Detailed First Office Action

The application relates to a multi-path detecting circuit used for CDMA system. An object of the invention is to provide a multi-path detecting circuit suitable for a CDMA receiver capable of fast and accurate multi-path detection. After examination, the opinions of the Examiner are proposed as follows:

Applicant(s)	NEC Corporation	Issuing Date: September 26, 2003
Patent Agent(s)	Haibo ZHU	
Application No.	01110503.8	
Title of Invention	Multi-Path Detecting Circuit and System

THE FIRST OFFICE ACTION

图 7

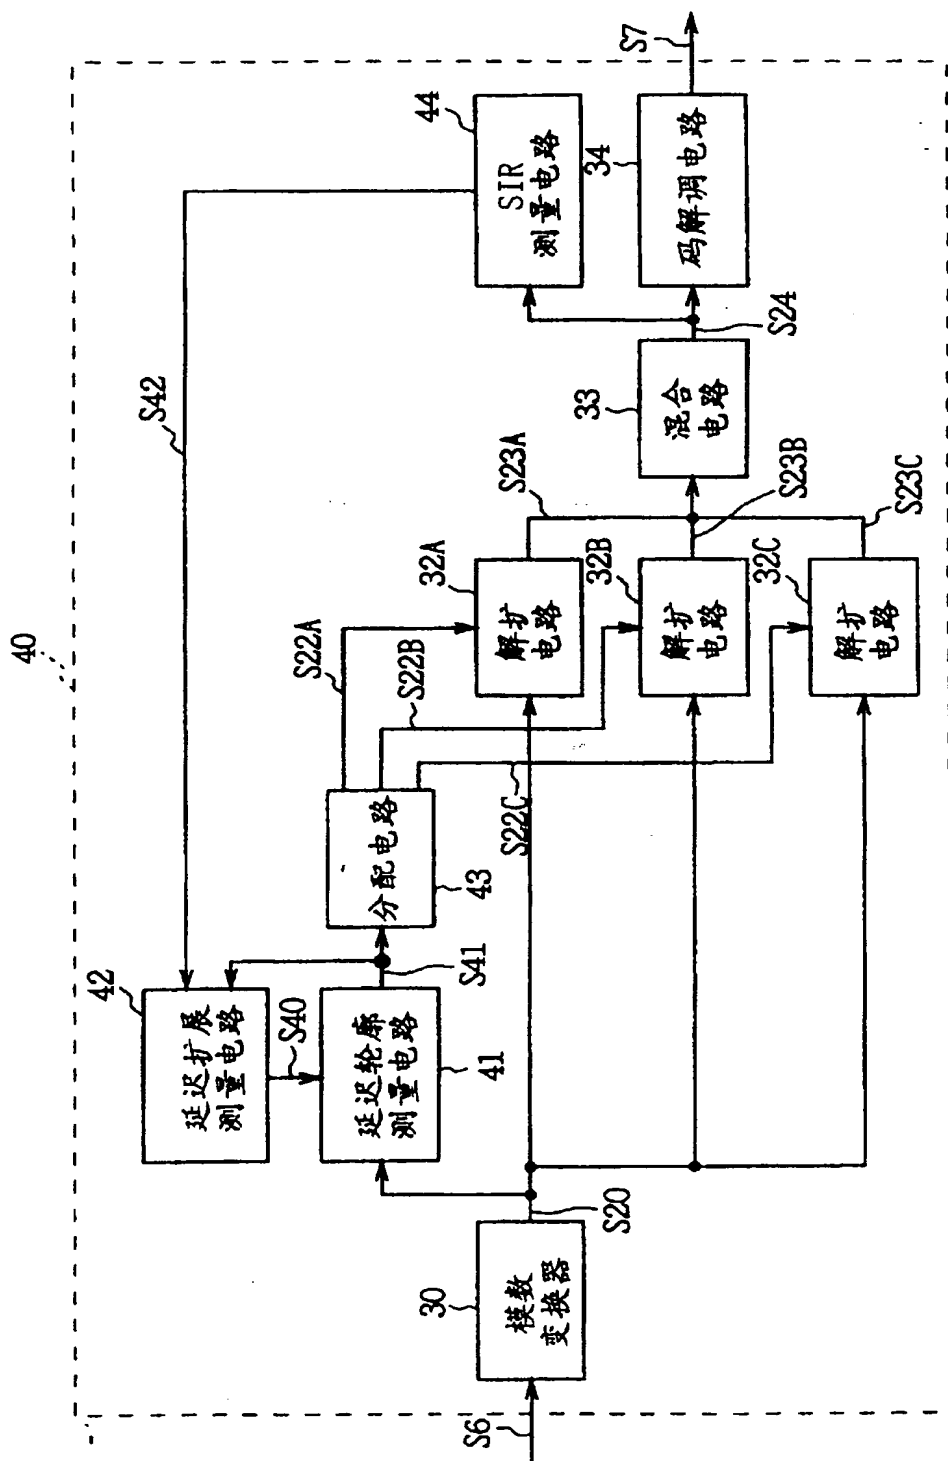
3、权利要求 7 不具备创造性,不符合专利法第二十二条第三款的规定。对比文件 1 公开了一种应用于 CDMA 系统具有路径检测功能的接收机电路的路径检测系统,并具体公开了以下的技术特征“通过平均延迟序列来确定分配给 RAKE 指状部分的路径”(参见该对比文件 1 说明书摘要、摘要附图);对比文件 2 公开了一种应用于 CDMA 通信系统的延迟轮廓检测装置电路,并具体公开了以下的技术特征“通过改变检测基带信号延迟轮廓的检测时间(即检测周期)来测量基带信号的延迟轮廓(即延迟分布)”(参见该对比文件 2 说明书第 7 页 25 行至第 8 页 27 行、说明书摘要及附图 7)。由此可见,对比文件 1 和对比文件 2 已经披露了该权利要求的全部技术特征。由于对比文件所公开的技术方案与该权利要求所要求保护的技术方案属于同一技术领域,在对比文件 1 的基础上结合对比文件 2 得出该权利要求所要求保护的技术方案,对所述技术领域的技术人员来说是显而易见的,而且两者的结合没有产生预料不到的技术效果,因此该权利要求 7 不具备突出的实质性特点和显著的进步,因而不具备创造性。

6、权利要求 10 不具备创造性，不符合专利法第二十二条第三款的规定。对比文件 1 公开了一种应用于 CDMA 系统具有路径检测功能的接收机，并具体公开了以下的技术特征“一个用于接收射频发送信号的天线部分；模数转换部分；多路径检测部分；用于合成在每个时序从 RAKE 指状部分接收的数据的 RAKE 合成部分；通过平均延迟序列来确定分配给 RAKE 指状部分的路径的平均延迟部分”（参见该对比文件 1 说明书摘要及说明书第 1 栏 38 行至第 10 栏 3 行、附图 6）；对比文件 2 公开了一种应用于通信系统的延迟轮廓检测装置电路，并具体公开了以下的技术特征“通过改变检测基带信号延迟轮廓的检测时间（即检测周期）来测量基带信号的延迟轮廓（即延迟分布）”（参见该对比文件 2 说明书第 7 页 25 行至第 8 页 27 行、说明书摘要及附图 7）。由此可见，对比文件 1 和对比文件 2 已经披露了该权利要求的全部技术特征。由于对比文件所公开的技术方案与该权利要求所要求保护的技术方案属于同一技术领域，在对比文件 1 的基础上结合对比文件 2 得出该权利要求所要求保护的技术方案，对所述技术领域的技术人员来说是显而易见的，而且两者的结合没有产生预料不到的技术效果，因此该权利要求 10 不具备突出的实质性特点和显著的进步，因而不具备创造性。

7、权利要求 11 也不具备创造性，不符合专利法第二十二条第三款的规定。对比文件 1 公开了一种应用于 CDMA 系统具有路径检测功能的接收机，并具体公开了以下的技术特征“一个用于接收射频发送信号的天线部分；模数转换部分；多路径检测部分；用于合成在每个时序从 RAKE 指状部分接收的数据的 RAKE 合成部分；通过平均延迟序列来确定分配给 RAKE 指状部分的路径的平均延迟部分”（参见该对比文件 1 说明书摘要及说明书第 1 栏 38 行至第 10 栏 3 行、附图 6）。对比文件 2 公开了一种应用于通信系统的延迟轮廓检测装置电路，

并具体公开了以下的技术特征“通过改变检测基带信号延迟轮廓的检测时间(即检测周期)来测量基带信号的延迟轮廓(即延迟分布)”(参见该对比文件2说明书第7页25行至第8页27行、说明书摘要及附图7)。由此可见,对比文件1和对比文件2已经披露了该权利要求的全部技术特征。由于对比文件所公开的技术方案与该权利要求所要求保护的技术方案属于同一技术领域,在对比文件1的基础上结合对比文件2得出该权利要求所要求保护的技术方案,对所述技术领域的技术人员来说是显而易见的,而且两者的结合没有产生预料不到的技术效果,因此该权利要求11不具备突出的实质性特点和显著的进步,因而不具备创造性。
